Access Compliance Report

Public Rights-of-Way

| Intersection ID: 31765 | Main Street: FIRST_RUN_CT | Cross Street: PINYON_PINE_LN | Location: E |
| ADA ID: B2766EB72B40 | Ramp Type: Perp | Initial Pass/Fail: Fail | Overall Compliance: No |

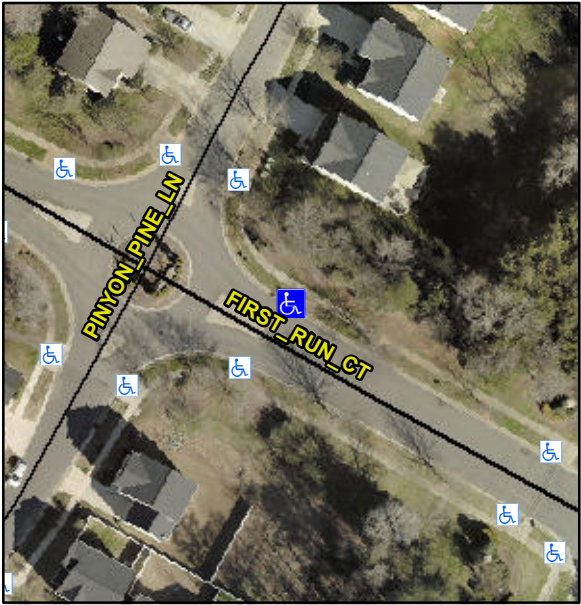
| Codes/Mitigation Info/Possible Solution | | | Field Measurements/Component Compliance | | |
|--|--|--|---|-----------------------------|-------------|
| | Remove & Replace Entire Ramp. | | No | Ramp Length (in) | 86.0 |
| <p>Surveyor Notes:</p> <p>N/A</p> <p>PROW/ADA:</p> <p>R304.2.2, R304.5.3</p> | | | N/A | Flare Type RT | N/A |
